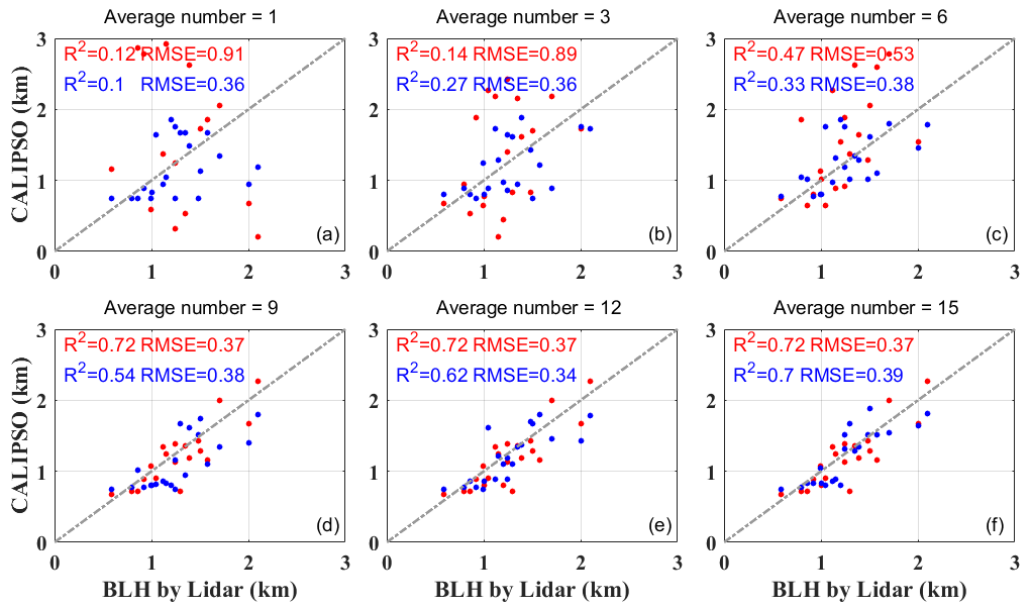
2. The reviewer's comment: In section 2 or section 3: Clarification for the averaging scheme for CALIPSO profiles by taking various horizontal smoothing number (i.e., 1, 3, 15 and 30) should be added. Also, to make the results more robust, the horizontal smoothing numbers of 1, 3, 6, 9, 12, 15, 18 and 30 (i.e., 1/3, 1, 2, 3, 4, 5, 6 and 10km in the along-track direction) are suggested to take. As a result, Fig. 9 can be expanded to take into account more sensitive results.

the various horizontal smoothing number (i.e., 1, 3, 15 and 30). According to your suggestion, the horizontal smoothing numbers of 1, 3, 6, 9, 12, and 15 (i.e., 1/3, 1, 2, 3, 4, and 5km in the along-track direction) are add to test the GDM algorithm. The new Fig.9 was shown below. Due to the correlation coefficient tends to be stable when the horizontal smoothing numbers was 12 and 15. So we did not analyze the comparison results when the horizontal smoothing numbers was 18 and 30.

The modification can be seen in the P6, line37-40 and P7, line 1-6. “Fig. 9 show the correlation coefficients between the BLH derived from CALIPSO and ground-based Lidar under the horizontal smoothing numbers of 1, 3, 6, 9, 12 and 15. The red and blue points represent the BLH calculated by GDM algorithm and MSD method, respectively. Figs. 9a, 9b and 9c show the comparison of BLH between CALIPSO and Lidar under the horizontal smoothing number of 1, 3 and 6. The correlation coefficients between the BLH derived by GDM algorithm and ground-based Lidar were 0.12, 0.14 and 0.47, respectively. Meanwhile, the correlation coefficients between the BLH derived by MSD method and ground-based Lidar were 0.1, 0.27 and 0.33. Figs. 9d, 9e and 9f show the comparison of BLH between CALIPSO and Lidar under the horizontal smoothing number of 9, 12 and 15. The correlation coefficients between the BLH derived by GDM algorithm and Lidar measurements were both 0.72, and the correlation coefficients between the BLH derived by MSD method and Lidar measurements were 0.54, 0.62 and 0.7, respectively.”
